# Reliability Analysis Update

Transmission Expansion Advisory Committee  
Feb. 3, 2026

# 2024 Window 1 Proposed Scope Changes

# Yeat Substation Relocation Update

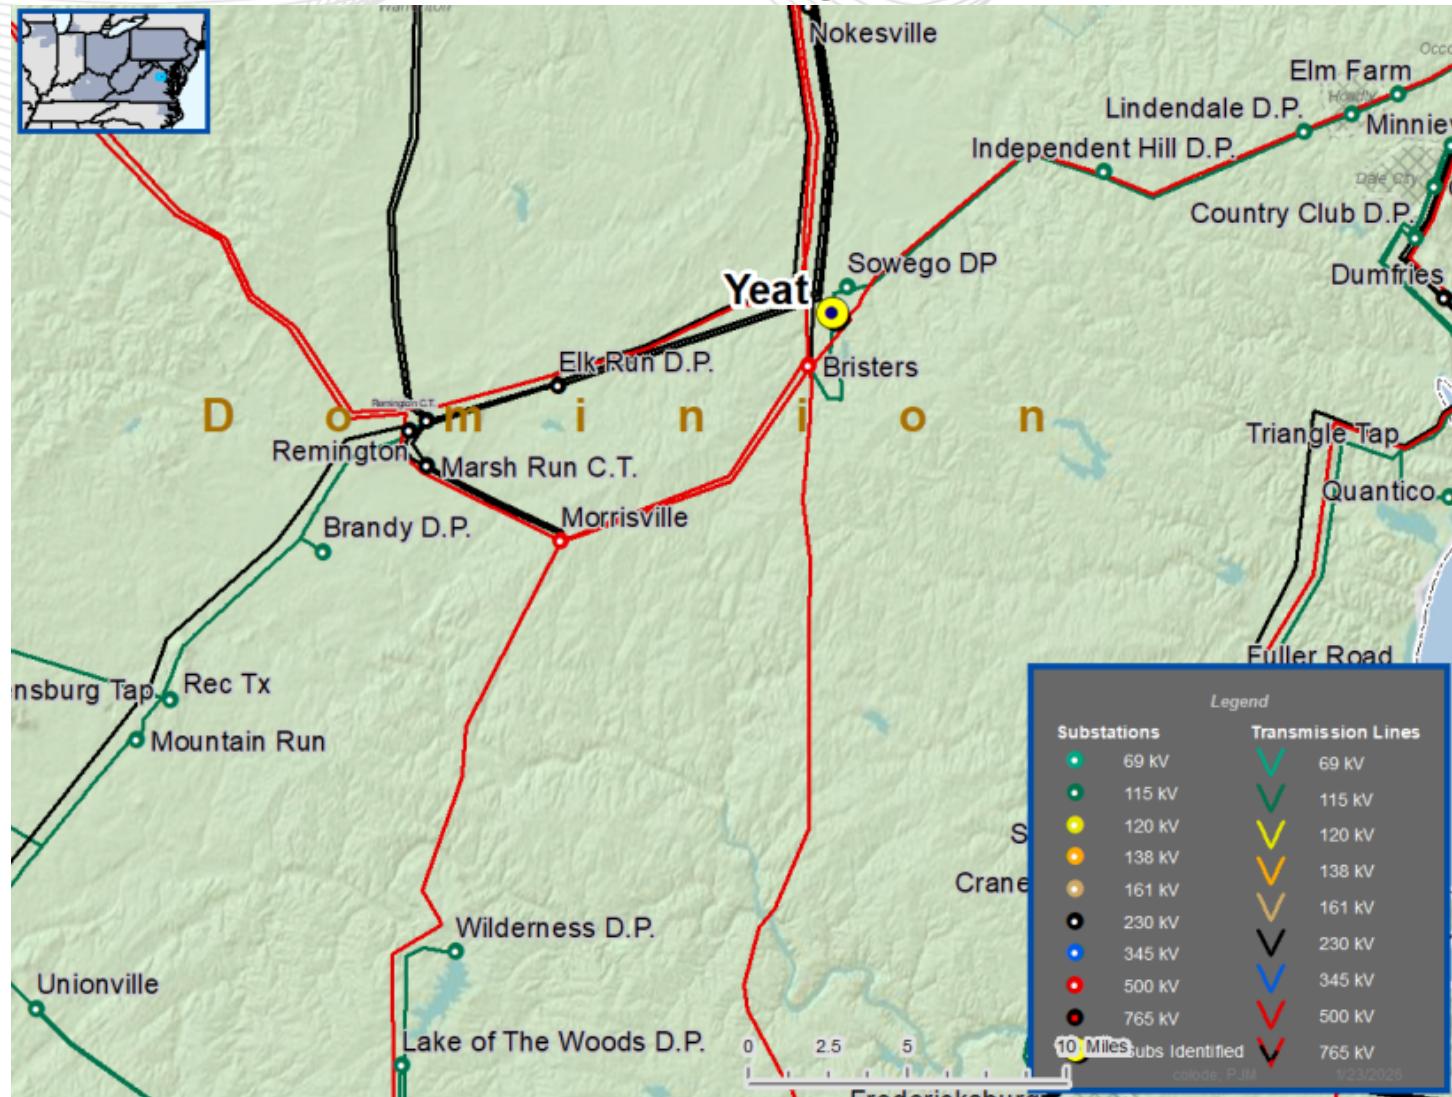
- Valley Link is evaluating “options” for relocating the Yeat substation further south
- Drivers for considering location change options:
  - Consideration of additional options before finalizing substation location
  - Potential enhancement to schedule certainty to meet project’s in-service date
  - Consider options to reduce new 765kV line mileage and associated cost/value benefits
  - Reduce potential residential, environmental, cultural and historical impacts

# Yeat Substation Relocation Update

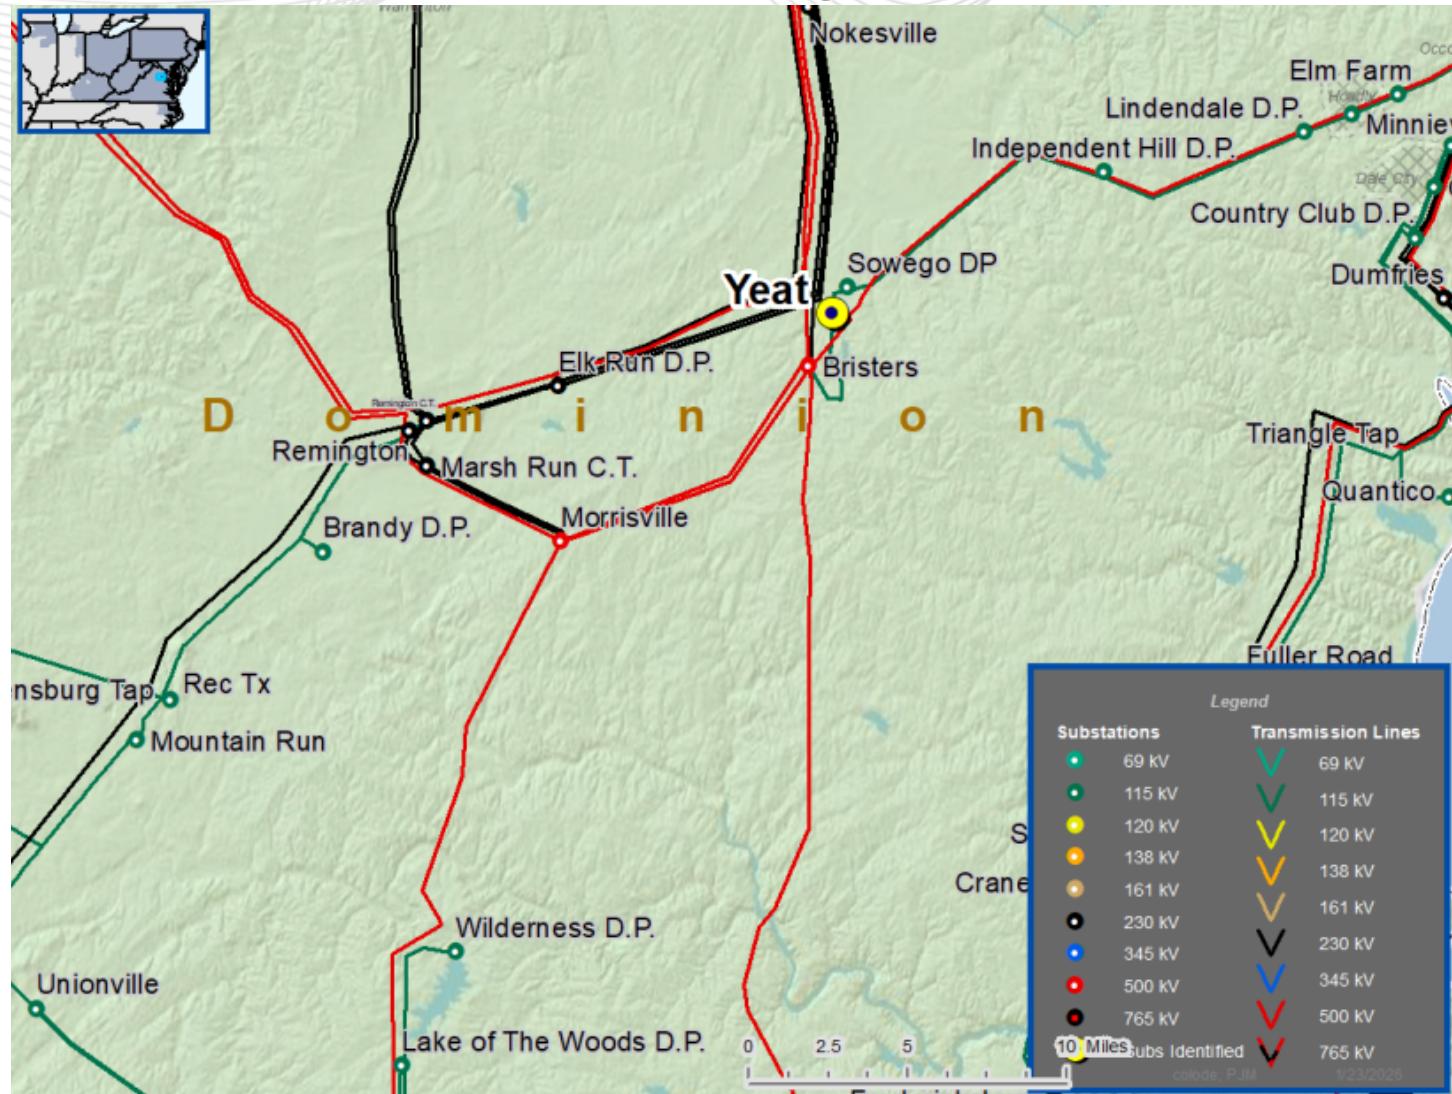
- Current scope of Yeat substation:
  - Build a new 765/500/230kV substation called Yeat. Install (2) 765/500 kV transformers. Cut in 500kV line Bristers – Ox and 500kV line Meadowbrook – Vint Hill into Yeat
    - **Estimated Cost: \$197.1M (b4000.357)**
  - At Yeat substation, install (1) 500/230kV transformer. Cut in 230kV line Vint Hill – Elk Run into Yeat substation
    - **Estimated Cost: \$45.6M (b4000.358)**
- Next steps are for Valley Link to finalize location following investigation of options and for PJM to perform the required reliability studies
- Scope change, if needed, to be brought forward at a future TEAC meeting
